Smart Motorways Programme

M4 J3 – 12

Package 1 (J8/9 to J12) Road Safety Audit Stage 2

Date: 21 October 2020

Location: Eastbound EA sign PS-B-67/3_50 (Drawing HA514451-HGN-S1_ML000000_Z-DR-CH-1019 Rev C02 Sheet 19 of 91) M4 westbound (chainage 556400)

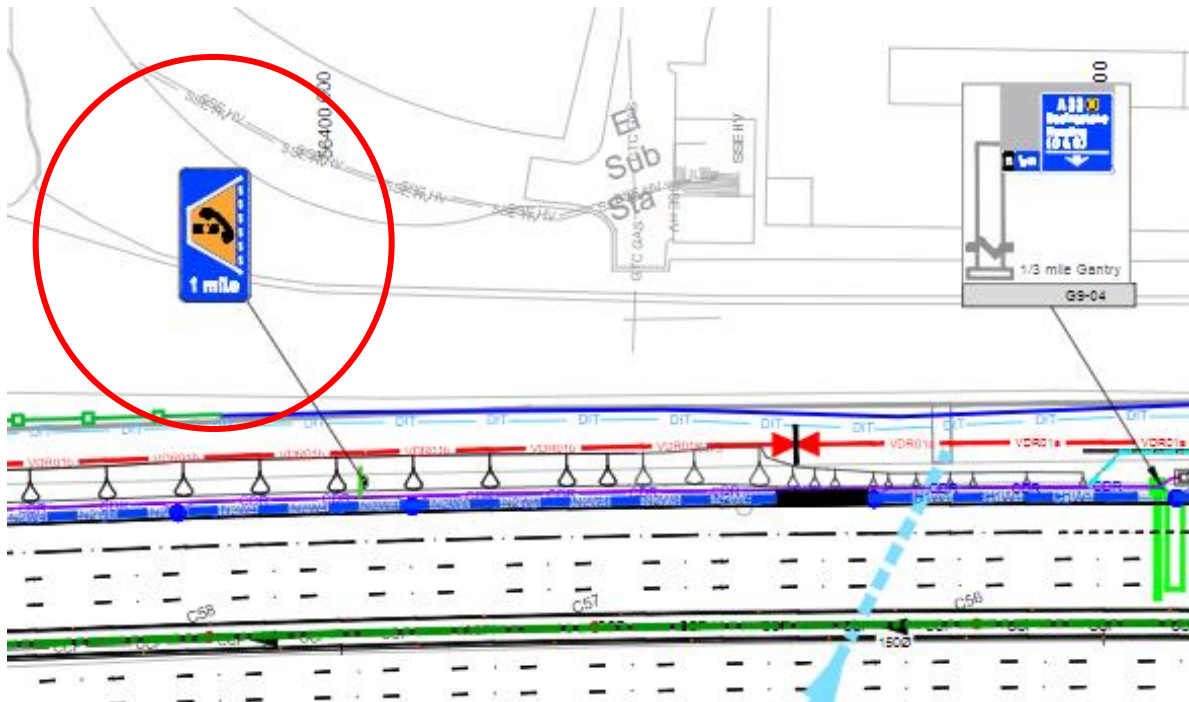
3.1.12 PROBLEM

Summary: EA sign provided does not correlate with an EA and may result in motorists traveling further to seek assistance

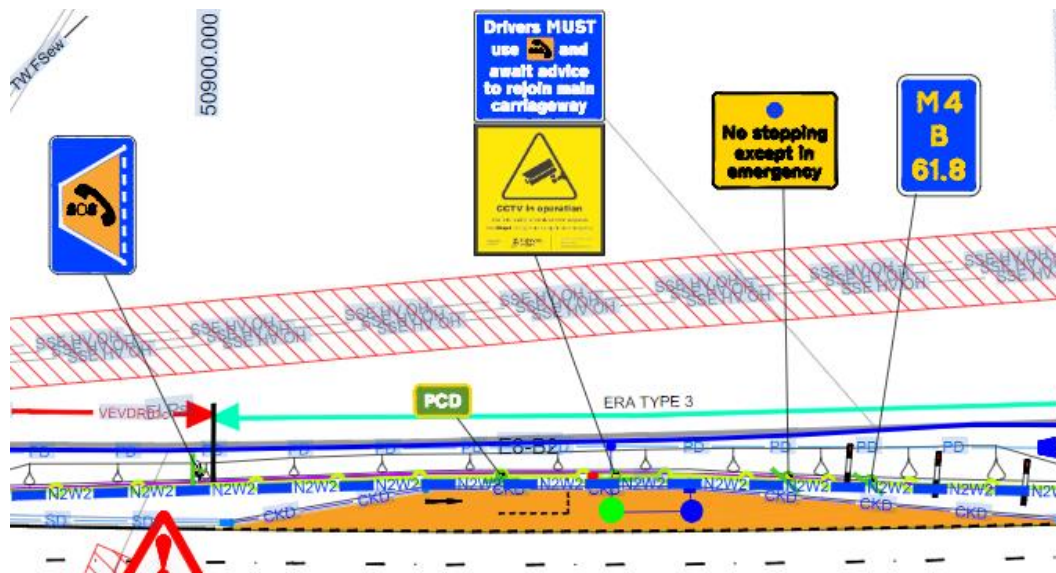
Recommendation

It is recommended that a yard sign is provided for continuity.

Location: EA E7-B4 (Drawing HA514451-CHHJ-HGN-S1_ML000000_Z-DR-CH-1055 Rev C02 Sheet 55 of 91) M4 eastbound (chainage 43300)

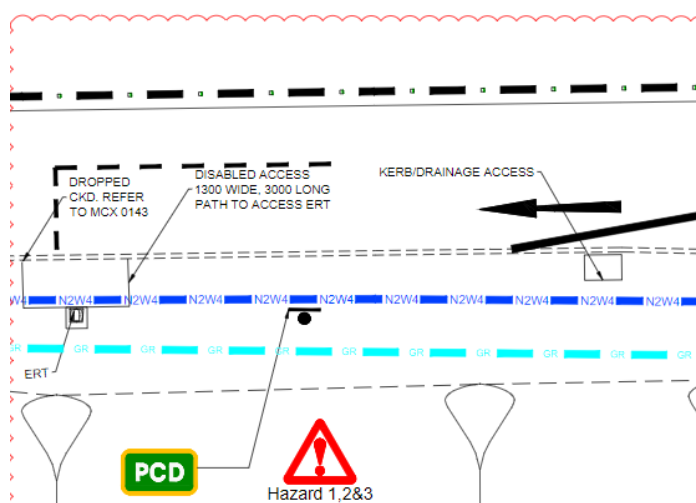
EA E7-B4 at chainage 43300 (eastbound) is on an embankment. The RRS drawings indicate that a pedestrian restraint is provided at the top of the slope, but this only covers the area immediately behind the emergency telephone, not the EA tapers. If a vehicle occupant exits the vehicle and crosses the RRS within the tapers (for instance if this is where their vehicle came to rest) they will be vulnerable to slips/falls down the slope.

It is recommended that pedestrian restraint is provided (outside of RRS working widths) at the top of the slope for the length of the EA.

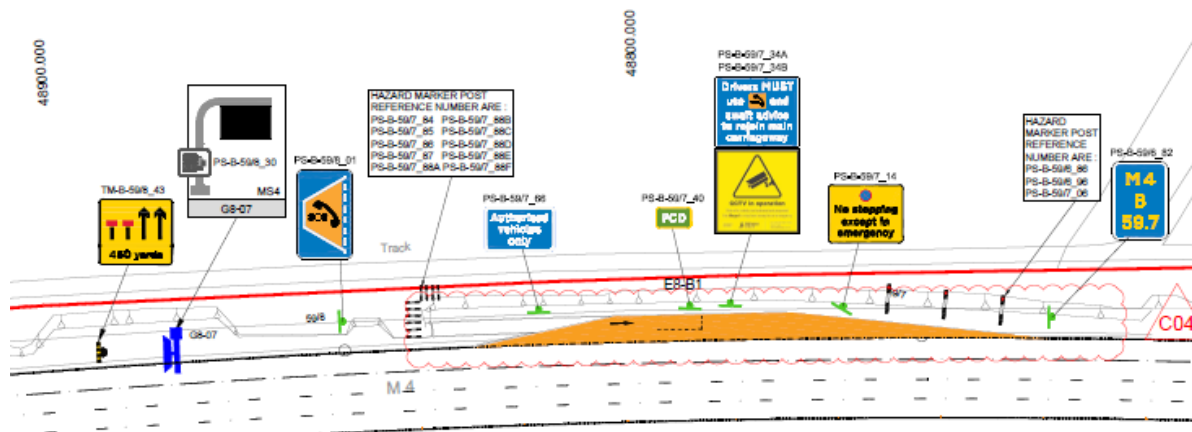
It is recommended that all A-chambers are protected by RRS.

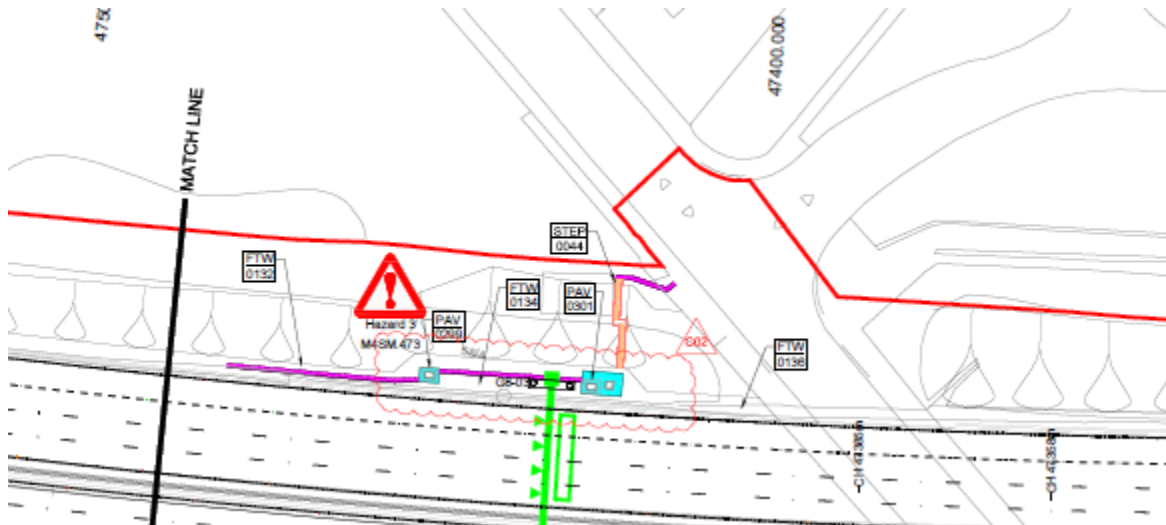
It is recommended that all footways and stepped accesses are accessible by operatives and are located outside of RRS working widths.

Location: Reading Road (Drawing HKF-S1_ZZ000000_Z-DR-CH-11044 Rev C02 Sheet 44 of 91) M4 eastbound (chainage 47420)

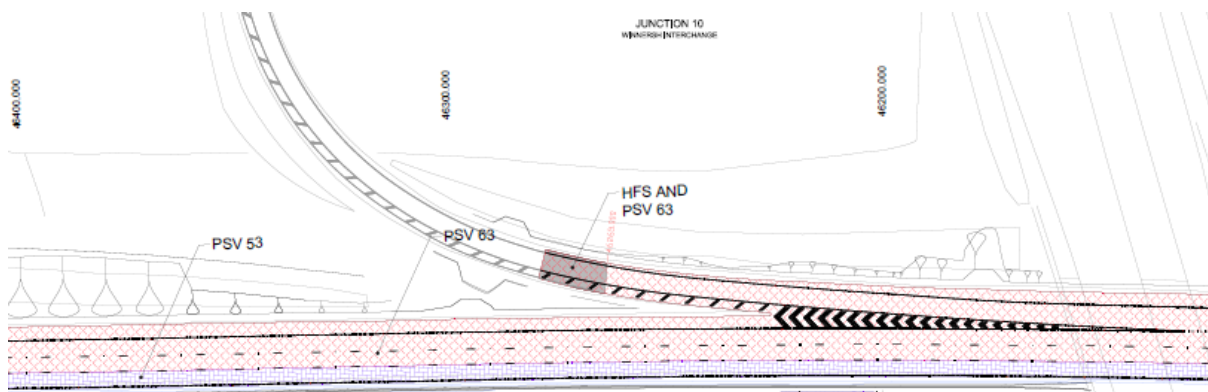
It is recommended that all operative access footways and steps that interact with public footways include controlled access and are clearly signed to enforce this.

Extract from drawing HPV-S1_ML000000_Z-DR-CH-0747 Revision C01

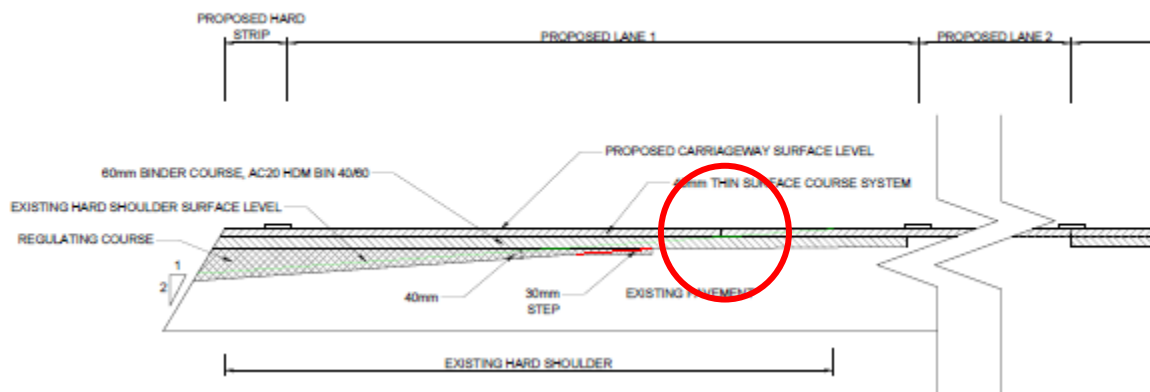
It is recommended that where HFS ties into an existing provision, new HFS is provided for the full length of the existing provision.

Extract from drawing HA514451-HGN-S1_ML000000_Z-DR-CH-1024 Rev C03

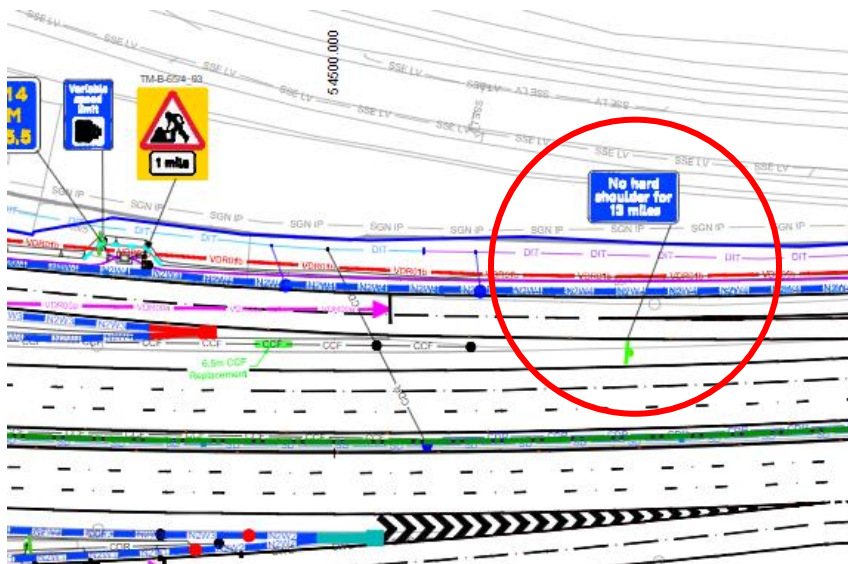
Summary: Signs located in front of the RRS or in gaps in the RRS

A number of signs are located in front of the RRS or in gaps in the RRS provision. It is unclear from the information provided whether the signs and post arrangements are passively safe. Examples include:

Location: Reading Motorway Service Area (MSA) merges and diverges (Drawing HA514451-CHHJ-HSN-S1_ZZZZZZZZ_Z-DR-CH-12011 Rev C04 Sheet 11 of 91) M4 eastbound and westbound (chainage 59200)

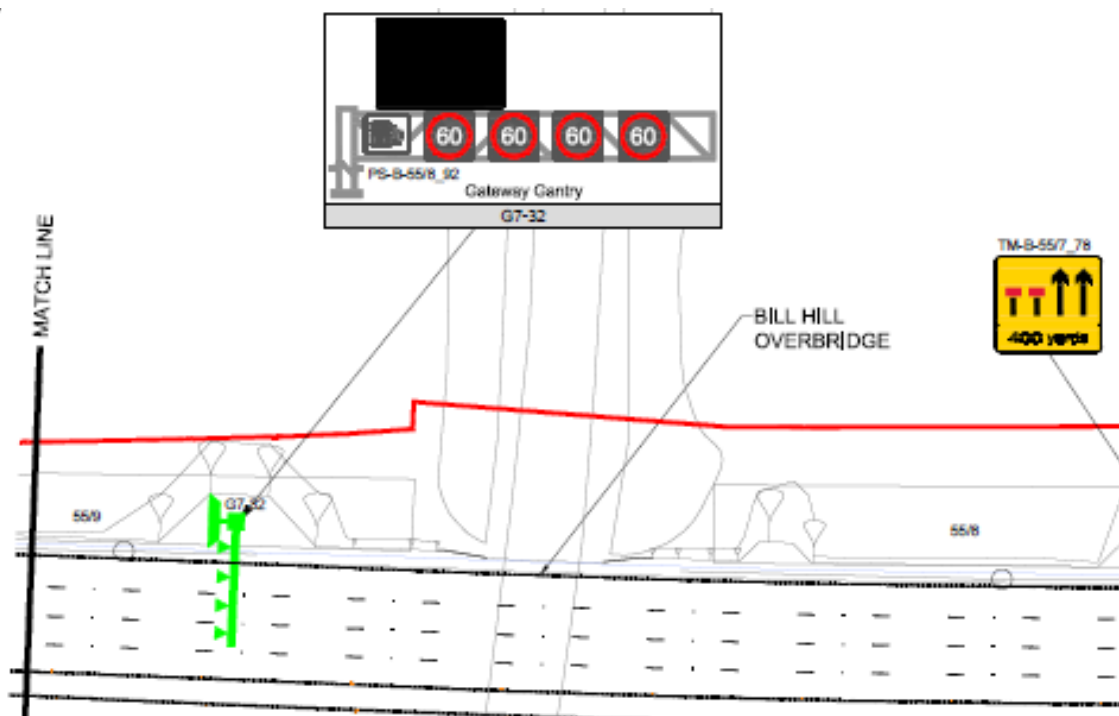
At the merges and diverges to/from Reading MSA the existing bend warning signs, chevrons, advisory speed limits and motorway regulations signs have been removed. This could result in drivers being unaware of the tight bends, speed limits and start/end of motorway regulations increasing the potential for loss of control collisions and inappropriate speeds.

It is recommended that existing signing of the bends, chevrons, advisory speed limits and motorway regulations signs are retained at all of the Reading MSA merges and diverges.

Extract from drawing showing G7-32 (chainage 44900),

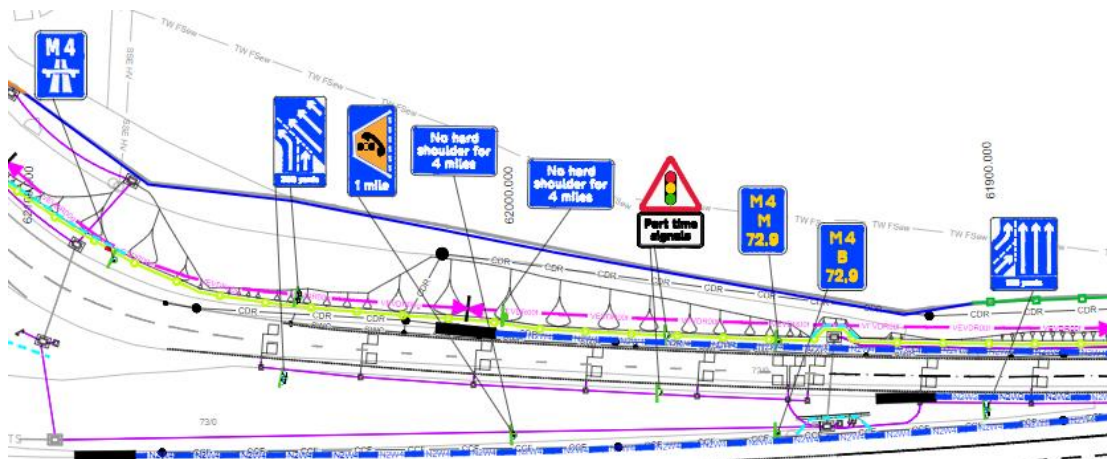
It is recommended that all gantries cover the full carriageway width, with signs aligned over the centre of each running lane.

Extract from drawing HA514451-HGN-S1_ML000000_Z-DR-CH-1005 Rev C02

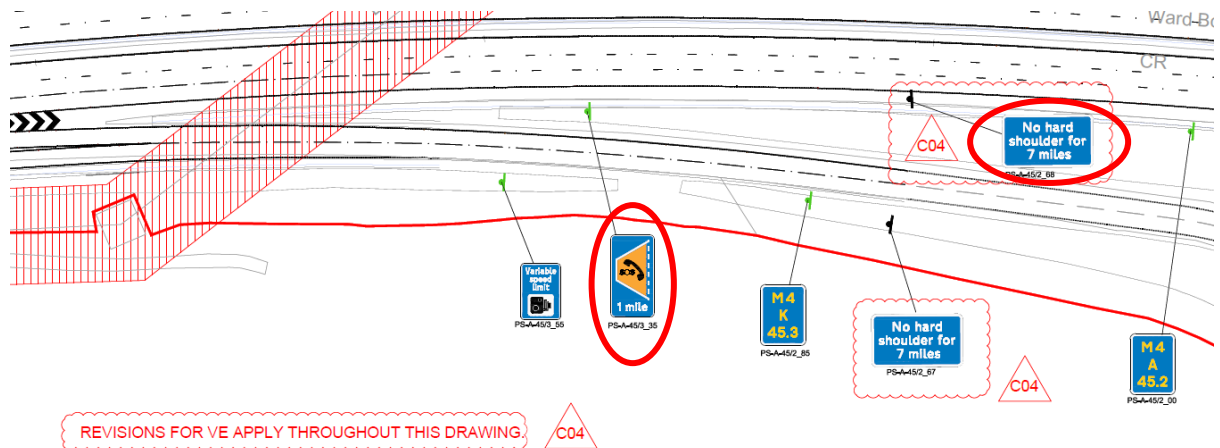
Summary: Visibility to sign faces partially or fully obscured by orientation of environmental barrier and other fencing

It is recommended that signs are either relocated so that sign faces are not obscured or mounted at suitable heights to ensure adequate forward visibility is provided.

Location: Junction 10 eastbound diverge (Drawing HSN-S1_ZZZZZZZ_Z-DR-CH-12046 Rev C04 Sheet 46 of 91 chainage 46700)

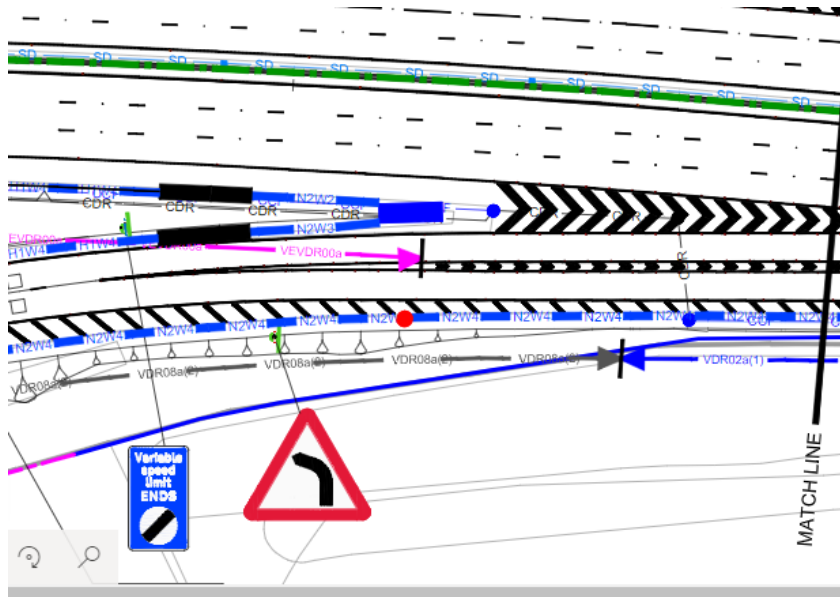
It is recommended that the bend warning sign is relocated and orientated away from the mainline carriageway.

Extract from drawing HA514451-HGN-S1_ML000000_Z-DR-CH-1049 Rev C02

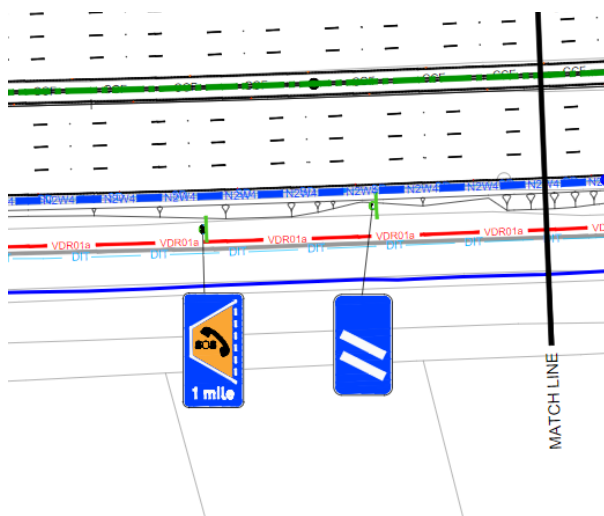
It is recommended that the variable speed limit ends sign is relocated to the nearside and orientated away from the mainline carriageway.

Location: Junction 12 westbound diverge (Drawing HA514451-CHHJ-HSN-S1_ZZZZZZZZ_Z-DR-CH-12003 Rev C04 Sheet 3 of 91)

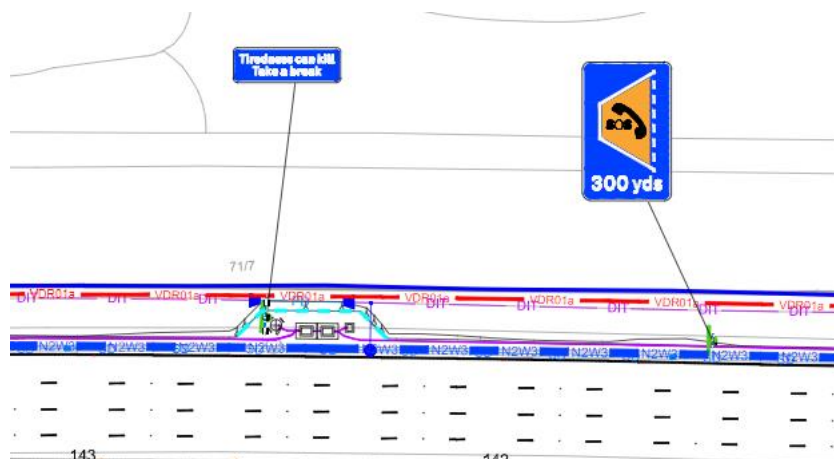
The junction 12 westbound diverge consists of two lanes. Neither lane designation signs or carriageway markings have been provided on the two lane approach, which then flares to four lanes at the circulatory. This may result in the potential for late lane changing manoeuvres and result in side impact or shunt collisions.

It is recommended that sufficient carriageway markings and lane destination signage is provided to inform motorists of the road layout ahead.

Location: Junction 8/9 eastbound diverge chainage 34400 (Drawing HA514451-CHHJ-HSN-S1_ZZZZZZZZ_Z-DR-CH-12080 Rev C03 Sheet 80 of 91)

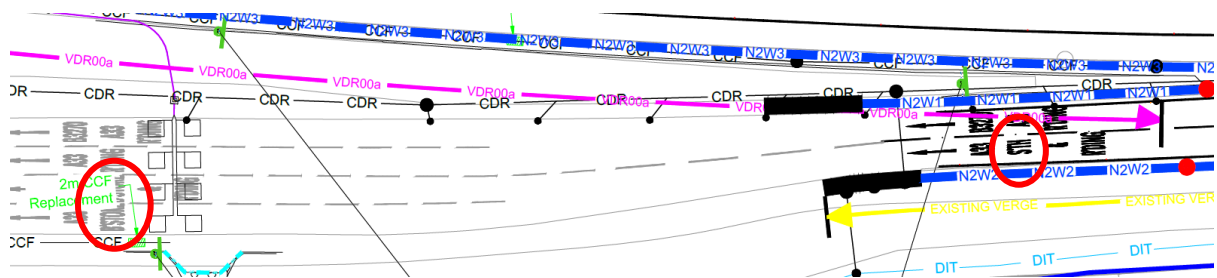
increases the potential for confusion and late lane changes (particularly from lane one) resulting in side impact collisions.

It is recommended that the carriageway markings and signing on approach to the junction 8/9 eastbound diverge are revised to be consistent.

Extract from drawing HGN-S1_ML000000_Z-DR-CH-1024 Revision C03

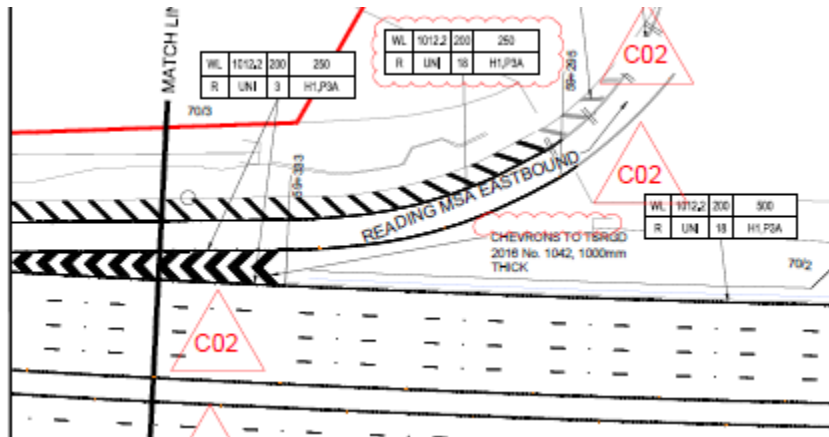
Location: Junction 11 westbound diverge chainage 54500 (Drawing HA514451-CHHJ-HGN-S1_ML000000_Z-DR-CH-1024 Rev C03 Sheet 24 of 91)

It is recommended that the carriageway markings in lane one of the two lane diverge are revised to include reference to Basingstoke, which provides consistency between the approach signage and existing markings on the diverge.

Reading Motorway Services eastbound diverge lane - image captured October 2018

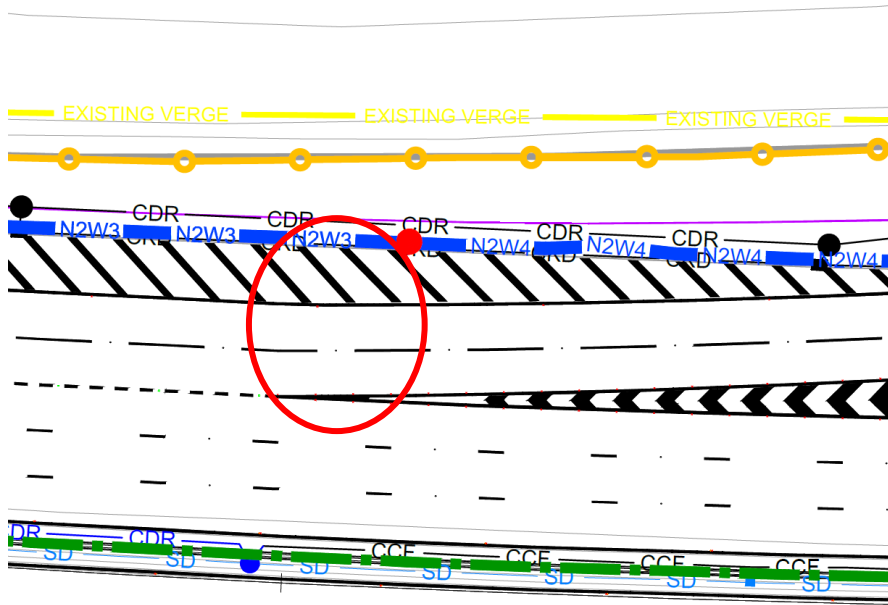
Location: Reading MSA chainage 52900 (Drawing HA514451-CHHJ-HMK-S1_ML000000_Z-DR-CH-1211 Rev C02 Sheet 11 of 91)

It is recommended that 'SLOW' carriageway markings to TSRGD Diagram 1024 are provided on the diverge lanes to the Reading MSA.

Extract from drawing HGN-S1_ML0000000_Z-DR-CH-1022 Rev C03

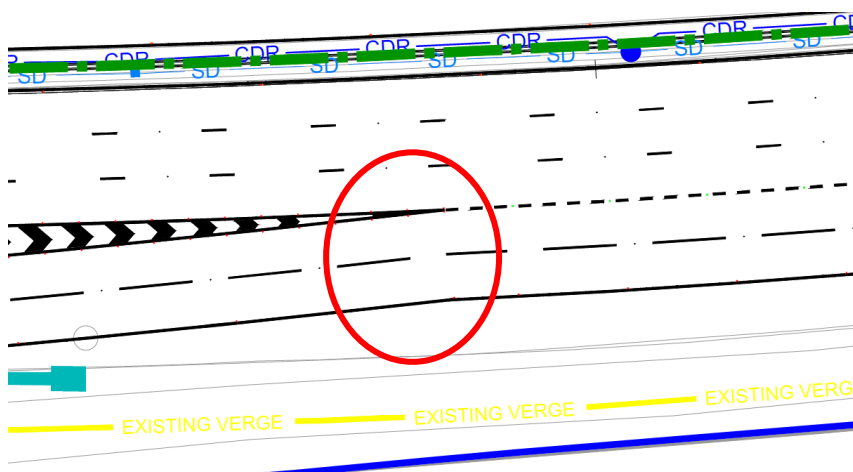
Location: Junction 11 eastbound diverge (Drawing HGN-S1_ML000000_Z-DR-CH-1022 Rev C03 Sheet 22 of 91) chainage 55300

Ensure that the warning markings provide a smooth left-hand bend transition.

Extract from drawing HGN-S1_ML0000000_Z-DR-CH-1024 Rev C03

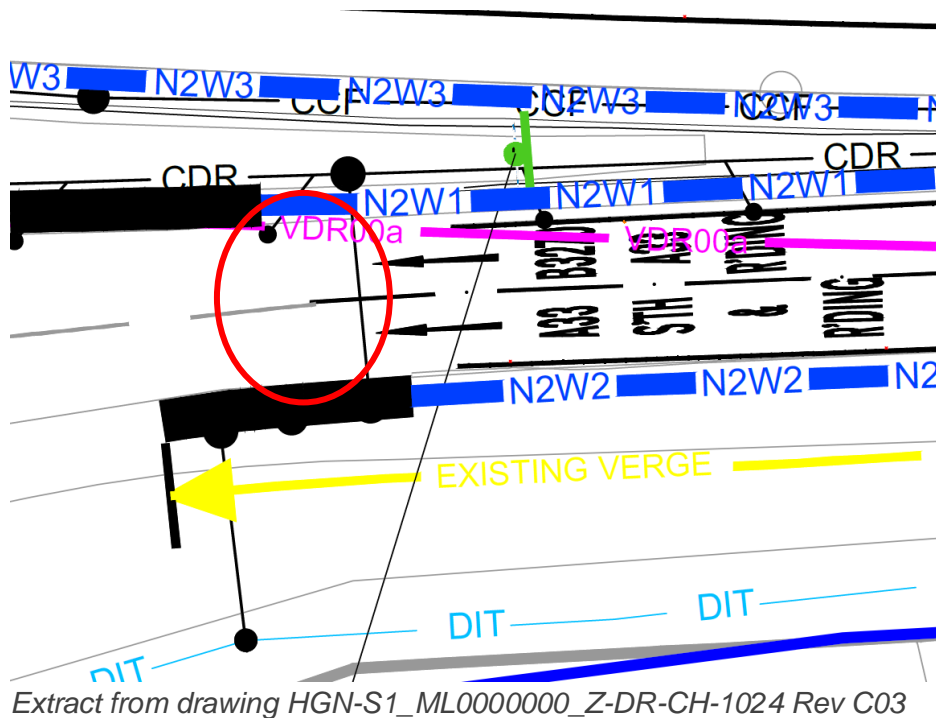
Location: Junction 11 westbound diverge (Drawing HGN-S1_ML0000000_Z-DR-CH-1024 Rev C03 Sheet 24 of 91) chainage 54400

Ensure that the warning markings provide a smooth left-hand bend transition.
